MONITORING YEAR 0 ANNUAL REPORT

CROSS CREEK RANCH SITE

DMS Project No. 100138
NCDEQ Contract No. 7879-01
DMS RFP No. 16-007879 / Issued: May 6, 2019
USACE Action ID No. 2020-00051
DWR Project No. 2020-0016
Data Collection Dates: February 2022 – July 2022

Subject: DRAFT MY0/As-Built Baseline Report & Record Drawings Review
Cross Creek Ranch Site
Yadkin River Basin – CU# 03040104
Montgomery County
DMS Project ID No. 100138
Contract #. 7879-01

Figure 1b. Current Condition Plan View
Cross Creek Ranch Site
DMS Project No. 100138
Monitoring Year 0 - 2022

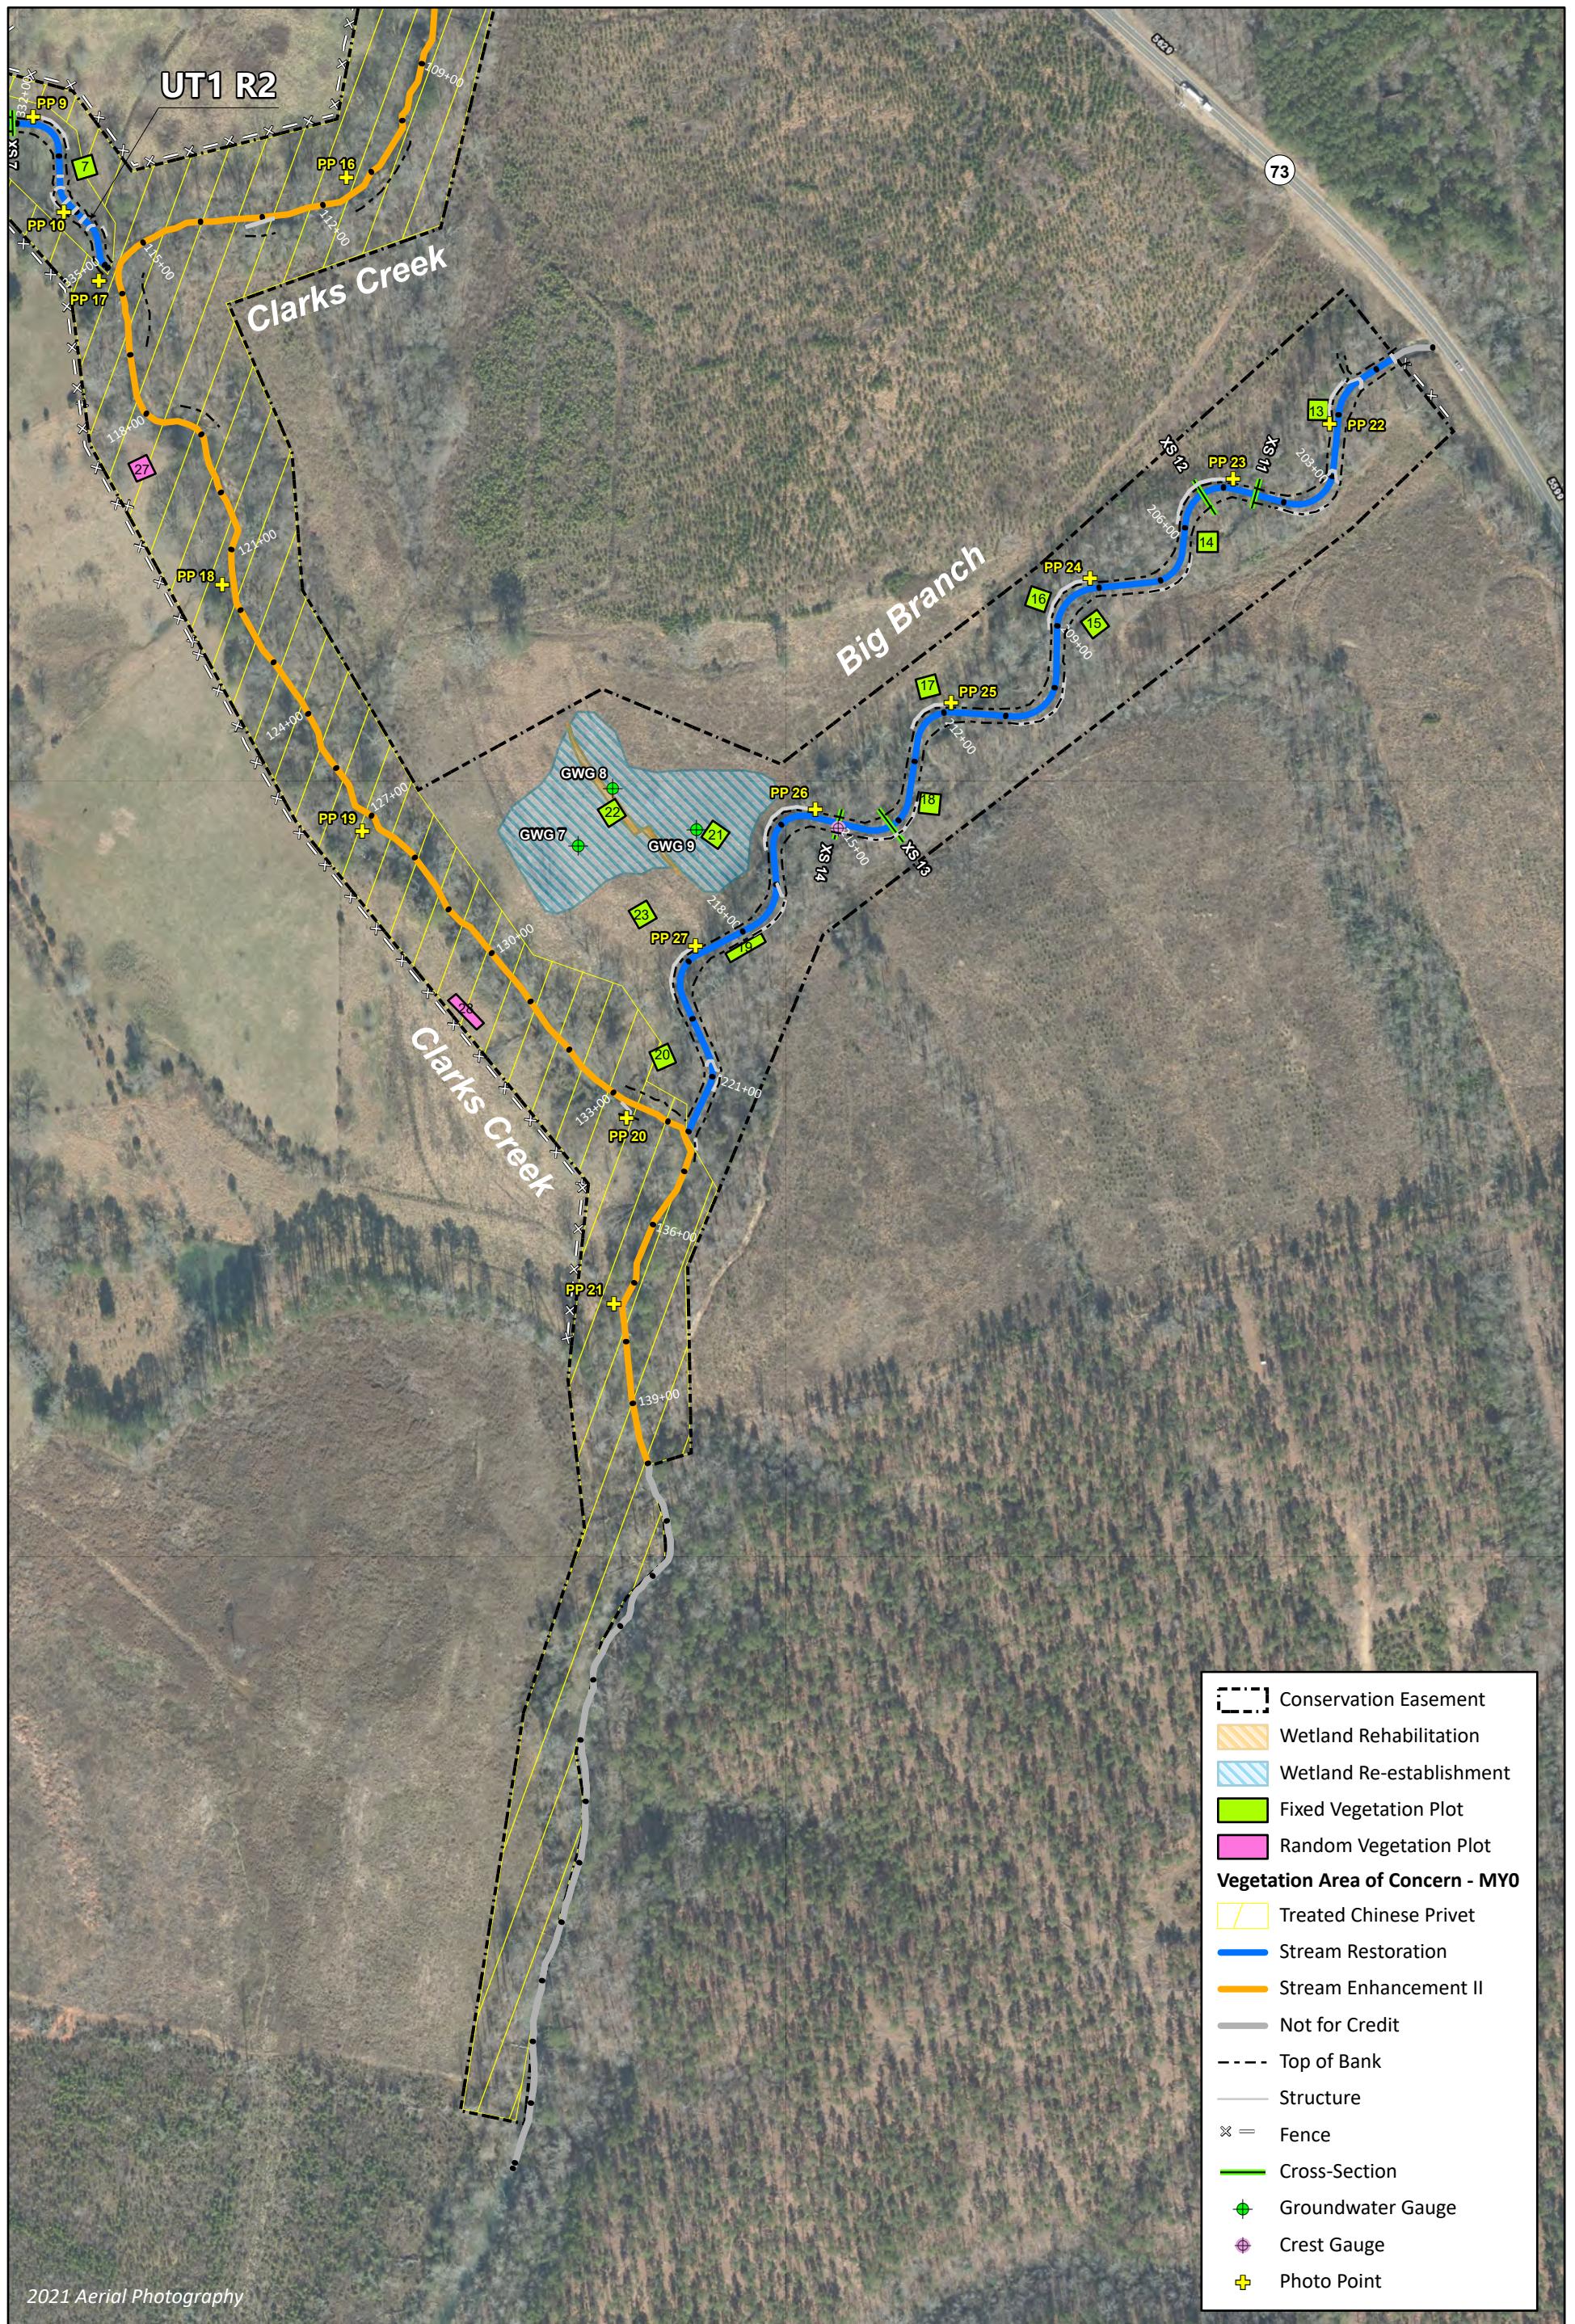
Figure 1 and Figure 1B - CCPV: Add the internal crossing shown on Sheet 1.2.1 of the Record Drawings to the figure.

Response: Sheet 1.2.1 of the Record Drawings mislabeled the utility easement, which is outside of the conservation easement, as an internal crossing. There is no internal or external crossing along Big Branch, therefore the CCPV does not show one. Sheet 1.2.1 has now been updated to accurately reflect the utility easement.

1.2.1

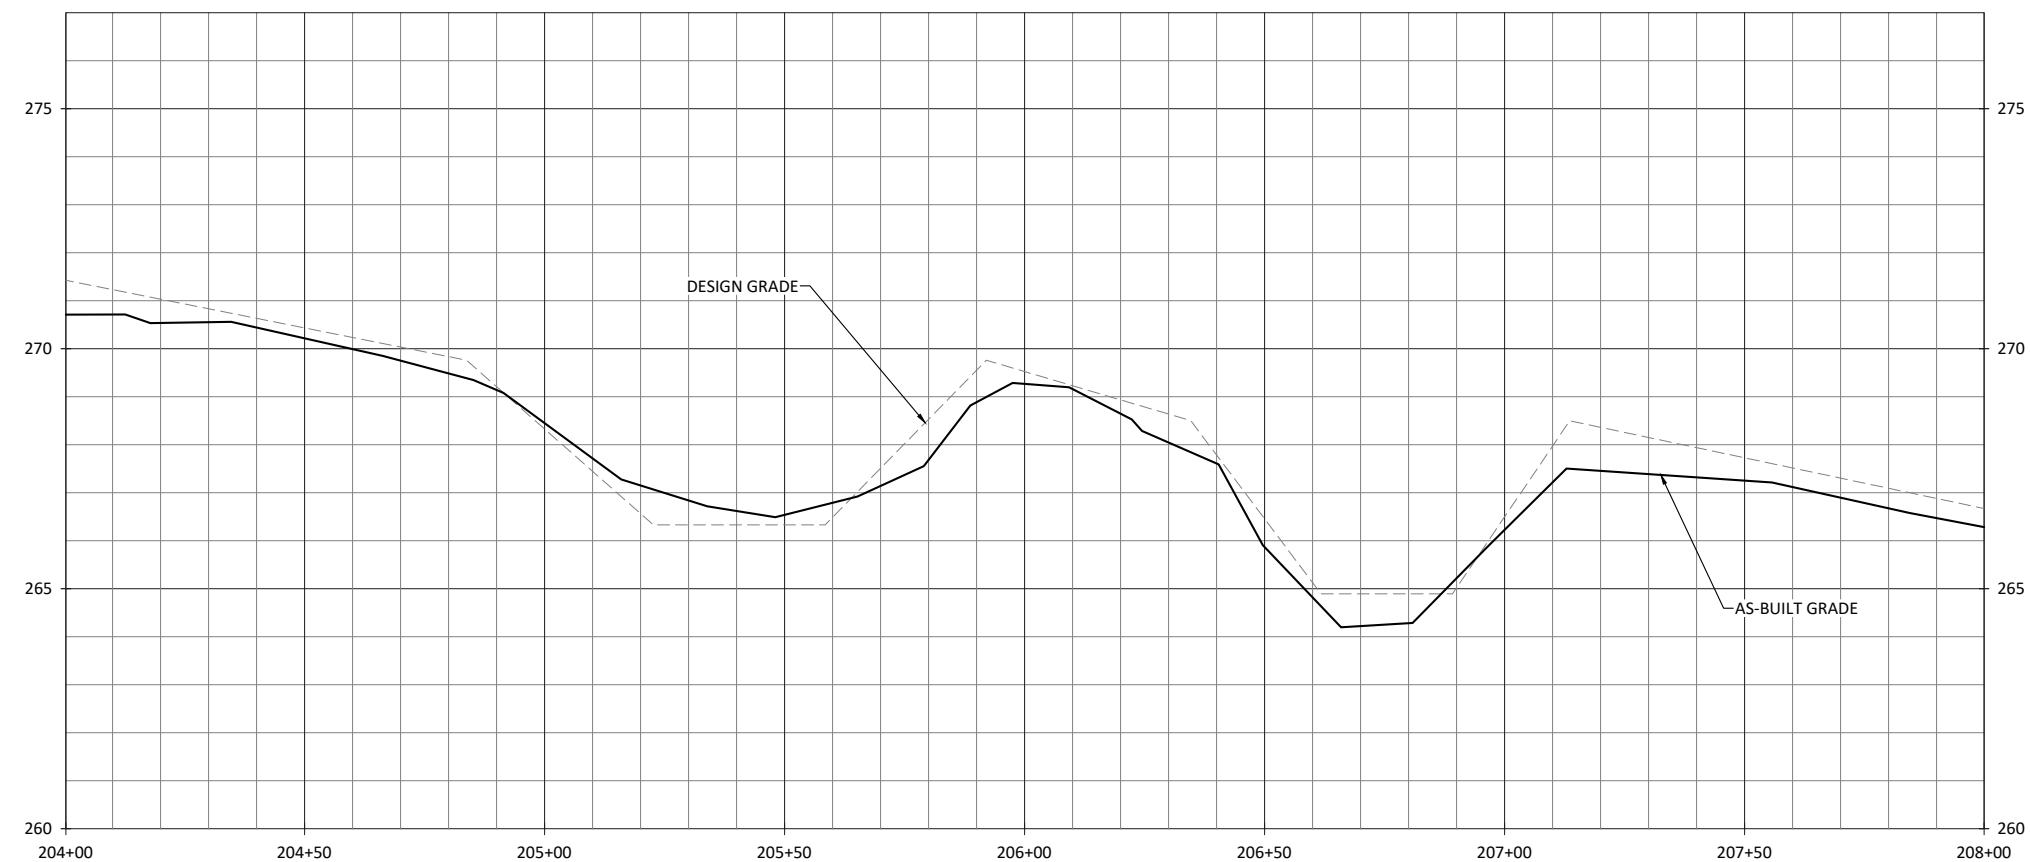
Appendix A - Culvert Crossing Photographs: Please add photos for the internal crossing at the beginning of Big Branch.

Response: Sheet 1.2.1 of the Record Drawings mislabeled the utility easement, which is outside of the conservation easement, as an internal crossing. There is no internal or external crossing along Big Branch, therefore a photograph is not needed. Sheet 1.2.1 has now been updated to accurately reflect the utility easement.

Sheet 1.4.1

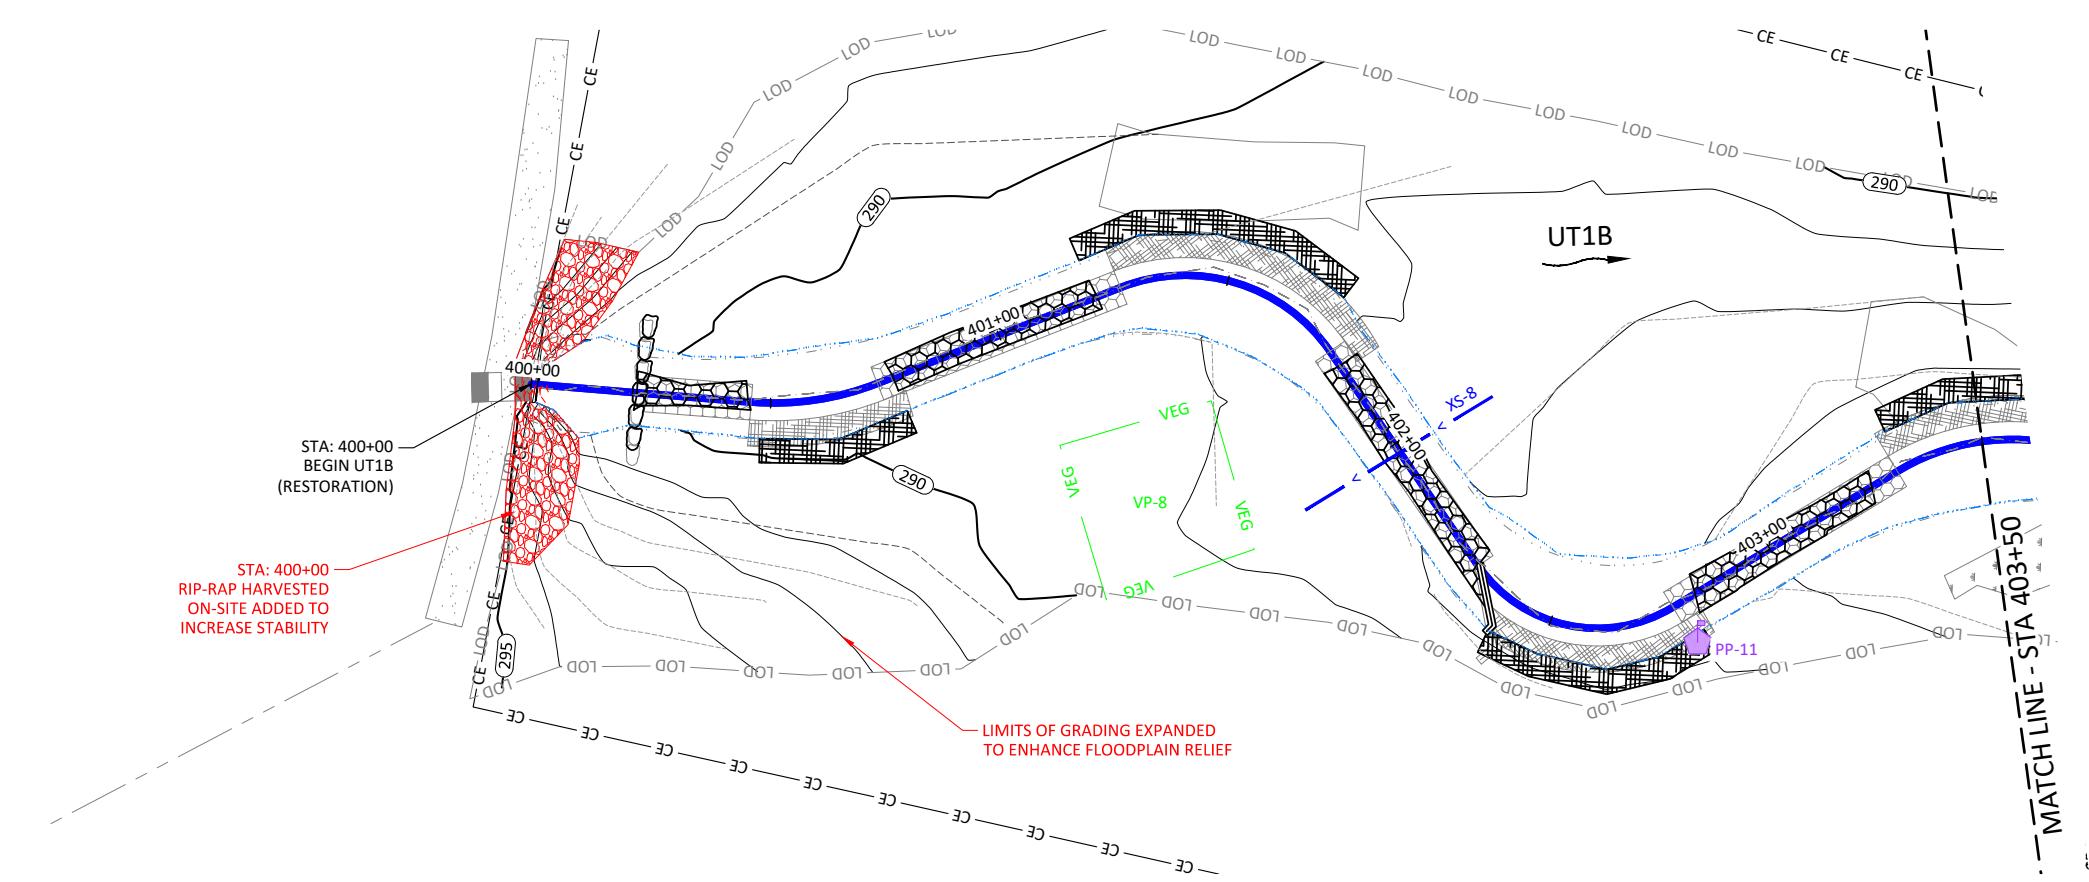
Record Drawings: Sheet 1.4.1: Native rock was installed within the conservation easement as stabilizing riprap along the road shoulder at the beginning of UT2B. Please indicate if this area will be a potential maintenance concern requiring construction access during monitoring or long-term Stewardship. If an easement modification is needed, IRT approval during this MY0/baseline review will be required prior to implementation.

Response: A field call made by the construction team was intended to stabilize an existing culvert that goes under a private road. No future maintenance is anticipated.
